Wandsworth Cycling Campaign

Pre-CRIM Submission

LCN Link 209 – Chelsea Bridge South to Cedars Road

November 2004

Figure 1. TfL screenline cycle survey, November 2002

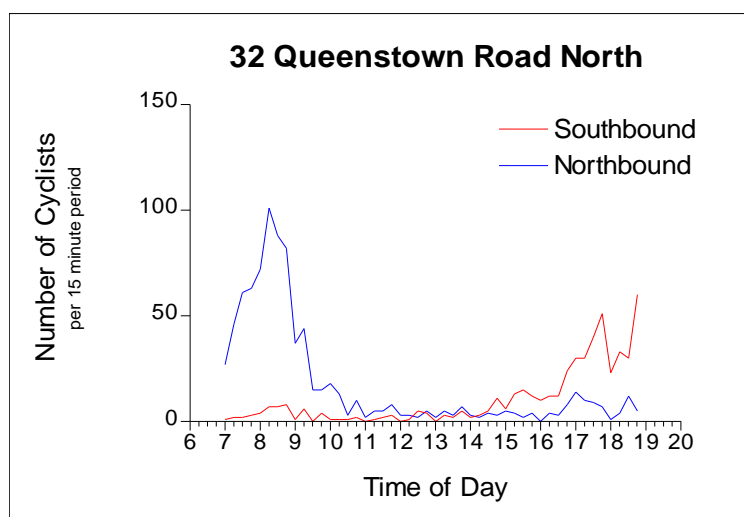
The cycle survey conducted in 2002 (Figure 1) also shows considerably more cyclists travelling north in the morning peak than using this link in the opposite direction in the evening peak. This disparity supports the reports from individual WCC members that they preferred not to use this link in a southbound direction.
